**MINERALS PROGRAM INSPECTION REPORT**  
**PHONE: (303) 866-3567**

<b>MINE NAME:</b> Dowe Flats Mine	<b>MINE/PROSPECTING ID#:</b> M-1993-041	<b>MINERAL:</b> Limestone and shale	<b>COUNTY:</b> Boulder
<b>INSPECTION TYPE:</b> Monitoring	<b>INSPECTOR(S):</b> Amy Eschberger	<b>INSP. DATE:</b> November 5, 2019	<b>INSP. TIME:</b> 14:30
<b>OPERATOR:</b> CEMEX, Inc.	<b>OPERATOR REPRESENTATIVE:</b> Cita Cisse, Scott Harcus, Robin Bay	<b>TYPE OF OPERATION:</b> 112c - Construction Regular Operation

### **Technical Revision No. 2 (Updated Mining and Reclamation Plans; Approved October 22, 2009):**

Red Outline = 1,854.45 acres = Approved Permit Area (location approximated based on approved maps in permit file)  
(Image data from 5/31/2018)

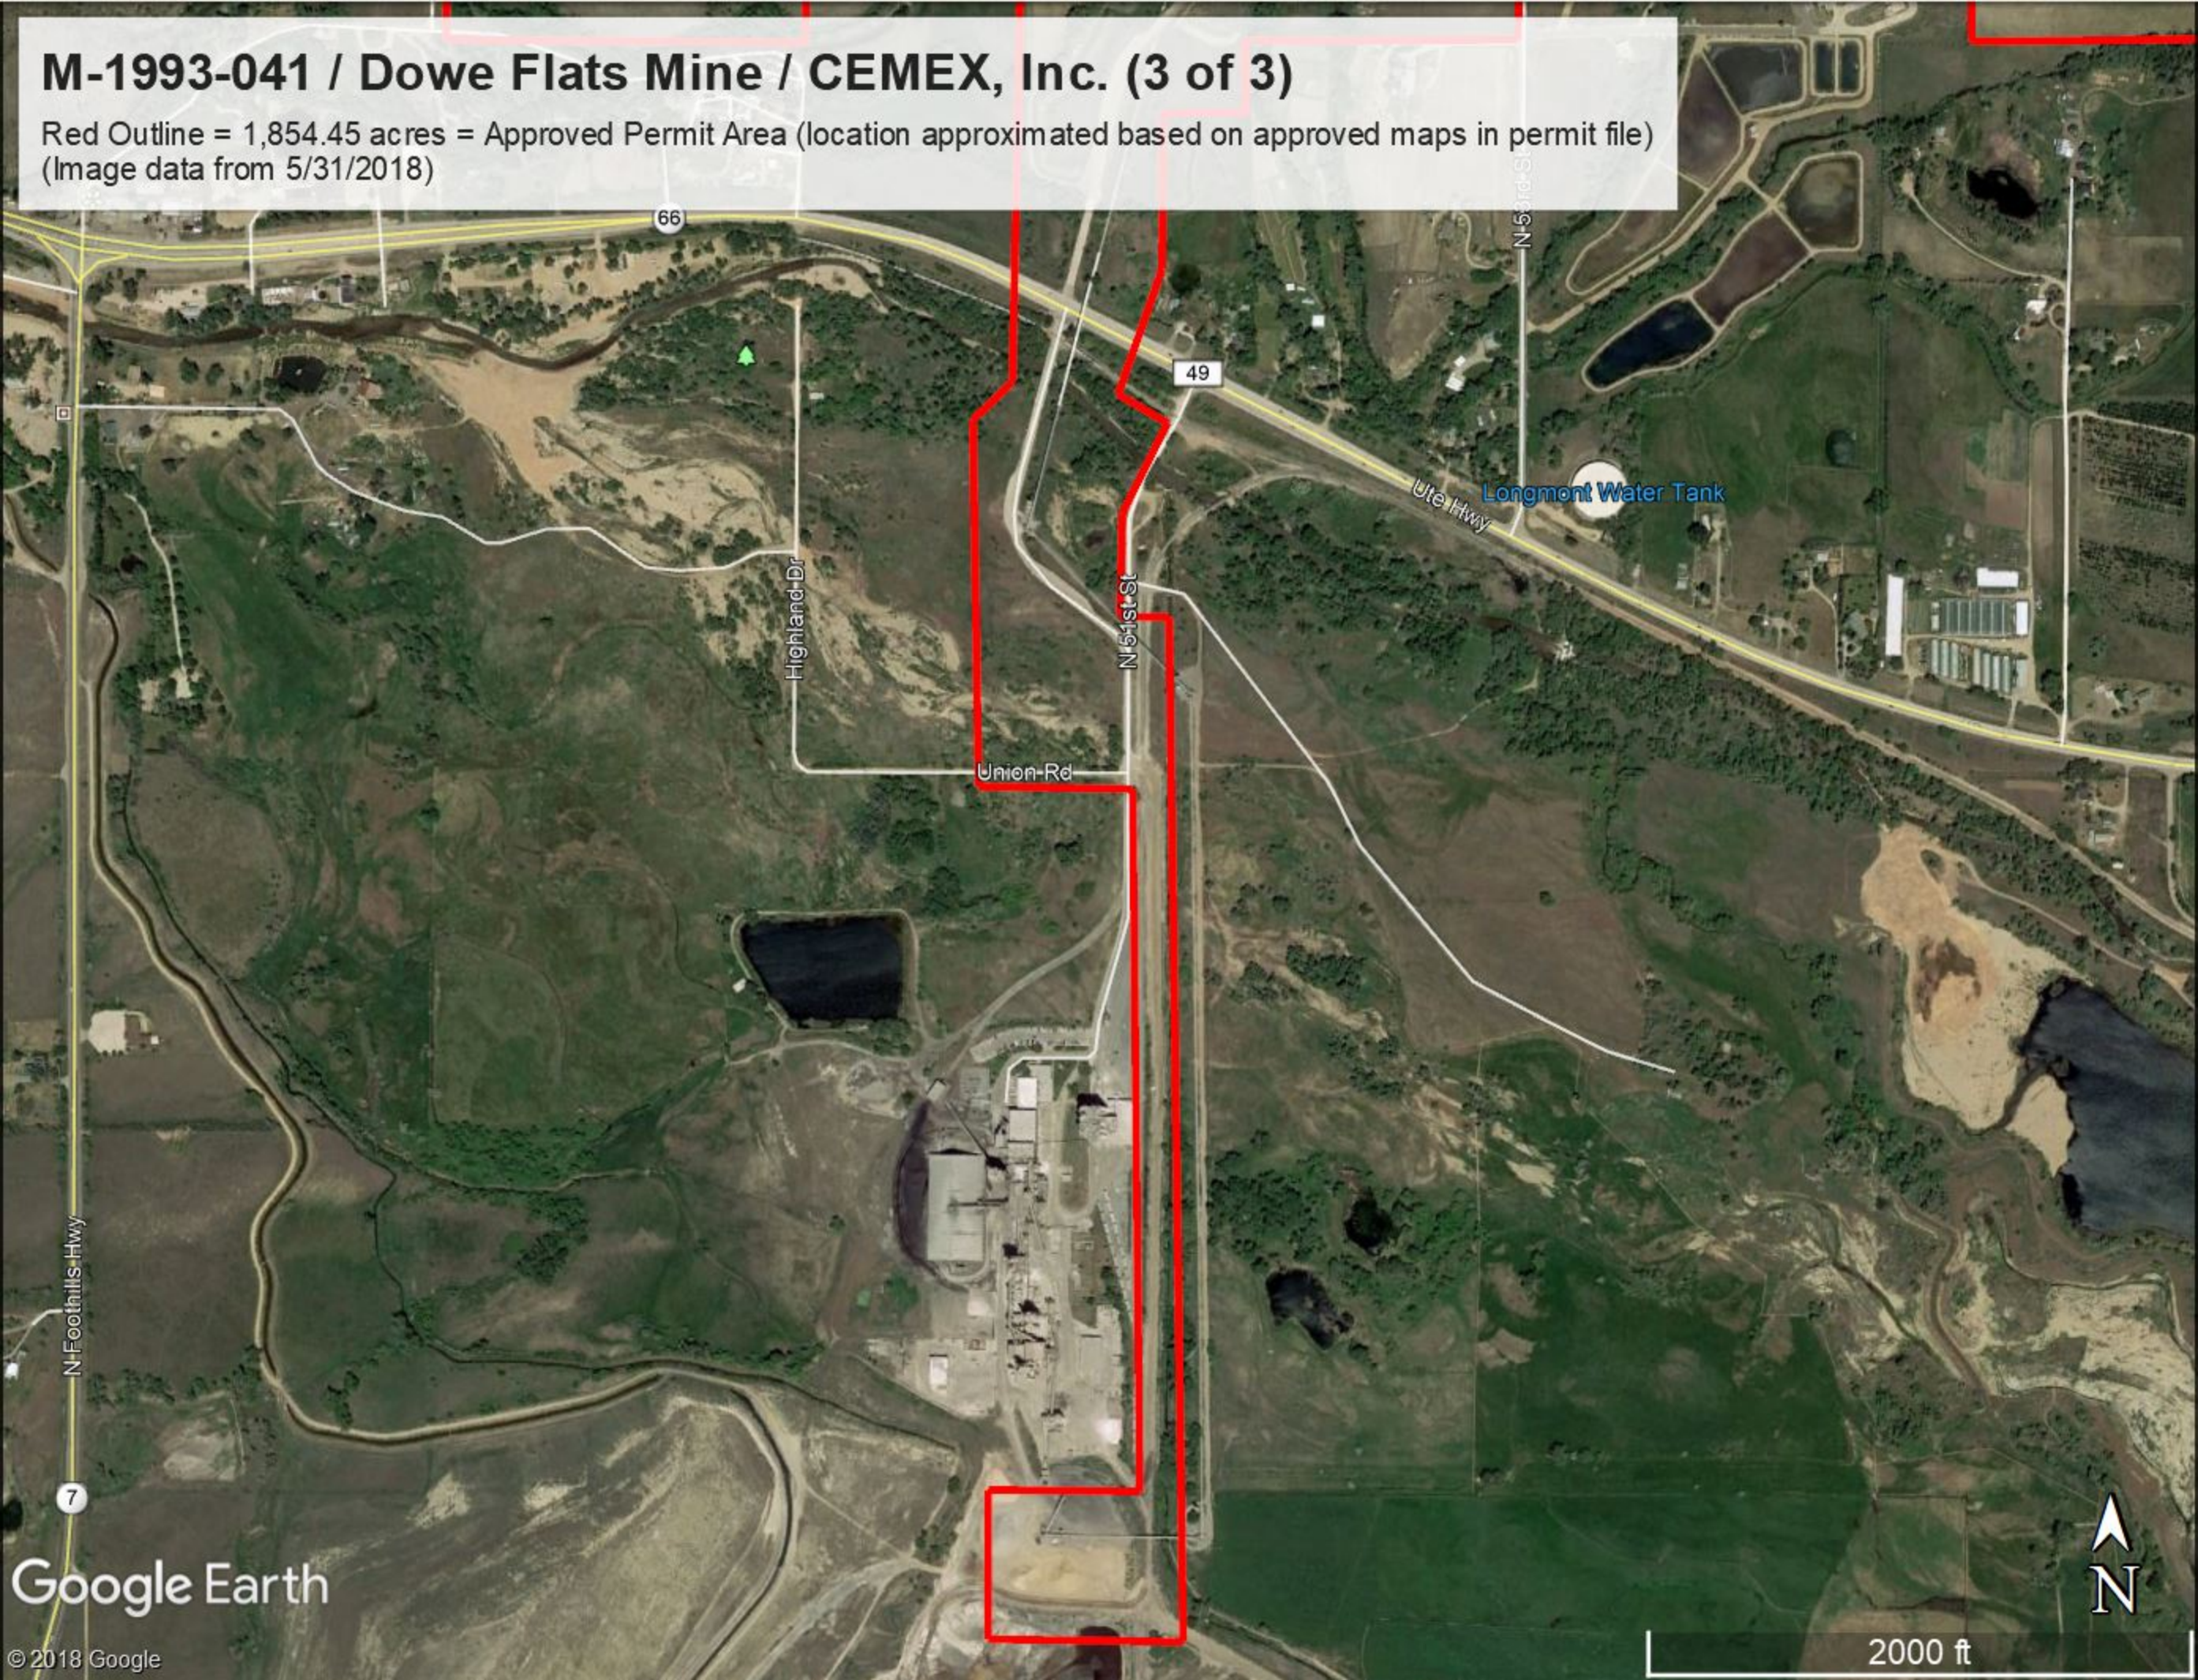
The Division was unable to find updated mining and reclamation plan maps in the permit file which depict the entire approved permit boundary and affected land boundary, particularly the portion located south of Hwy 66. Therefore, the operator will need to provide updated mining and reclamation plan maps for the site that meet the requirements of Rules 6.2.1(2), 6.4.3, and 6.4.6 (see enclosed rules). These maps should depict both the approved permit boundary (comprising 1,854.45 acres) and the affected lands boundary (comprising 464.9 acres). These updated maps should be submitted with the Technical Revision required for Problems #1 and #2 cited in this report (see pages 1 and 2). Enclosed with this report are a total of 12 site maps that were submitted with the original application, AM-1, AR-1, AR-2, and TR-2, which the operator may find useful. Also enclosed with this report are Google Earth images 1-3 of the site showing what the Division believes to be the approved permit area based on the approved maps in the permit file.

- c) Provide an updated mining plan map that depicts the entire approved permit boundary and affected lands boundary (including areas south of Hwy 66), and meets the requirements of Rules 6.2.1(2) and 6.4.3.

- d) Provide an updated reclamation plan map that depicts the entire approved permit boundary and affected lands boundary (including areas south of Hwy 66), and meets the requirements of Rules 6.2.1(2) and 6.4.6.
